SUBJECT: ① Newspaper accounts

③ Code requirements on 3/11
taper

④ Bechtel specification WQ-2
allegation.

} San
Onofre
allegation

FIG. NB-4233-1 BUTTWELD ALIGNMENT TOLERANCES AND ACCEPTABLE SLOPES FOR UNEQUAL I.D. AND O. D. WHEN INSIDE SURFACE IS INACCESSIBLE FOR WELDING OR FAIRING

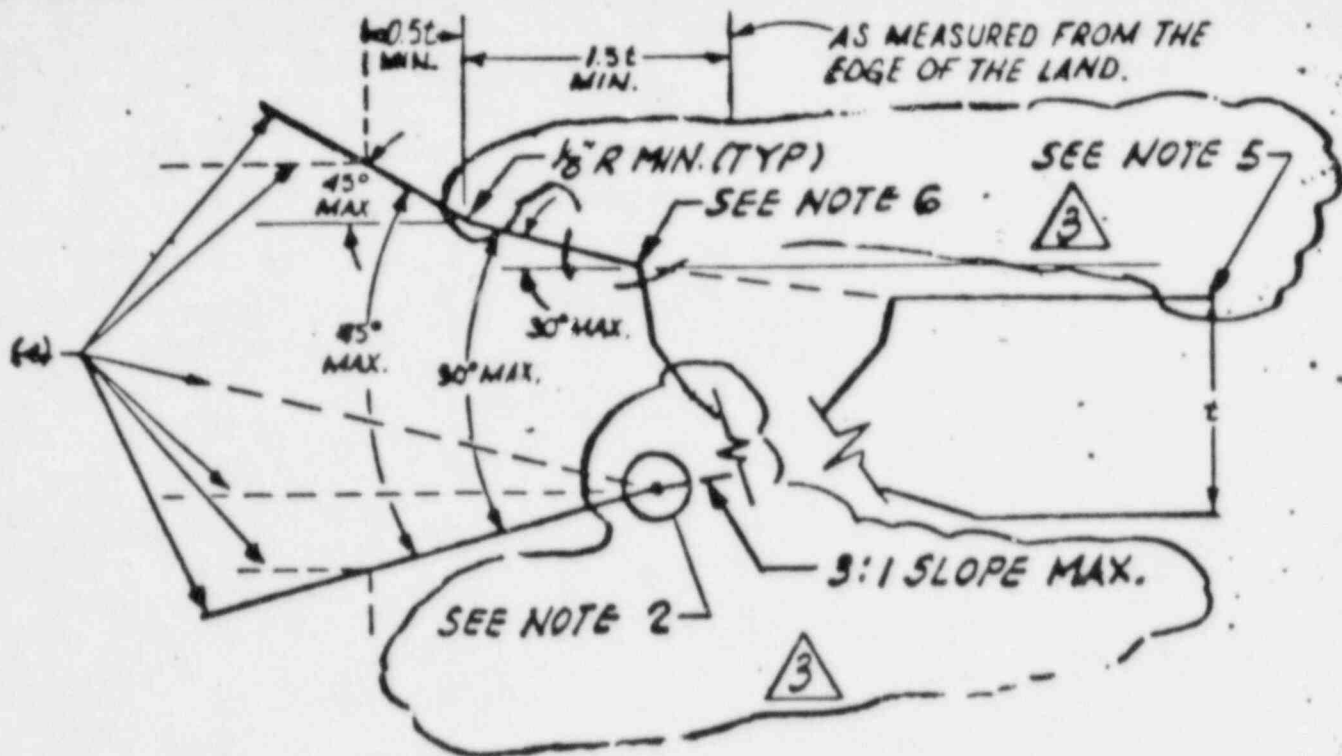
(13) Bechtel specification WQ-2, Sheet 20, note 1, requires, "shall not exceed $\frac{1}{8}$ inch ..." regarding maximum groove weld reinforcement height at Midland Michigan's twin nuclear plant. This requirement should read "shall not exceed $\frac{1}{8}$ inch ..." as required by the ASME Section III code on groove weld reinforcement. The $\frac{1}{8}$ inch height may be, also mistakenly implemented at San Onofre.

NB-4232.1 Fairing of Offsets. Any offset within the allowable tolerance provided above shall be faired to at least a 3 to 1 taper over the width of the finished weld or, if necessary, by adding additional weld metal beyond what would otherwise be the edge of the weld. In addition, offsets greater than those stated in Table NB-4232-1 are acceptable provided the requirements of NB-3200 are met.
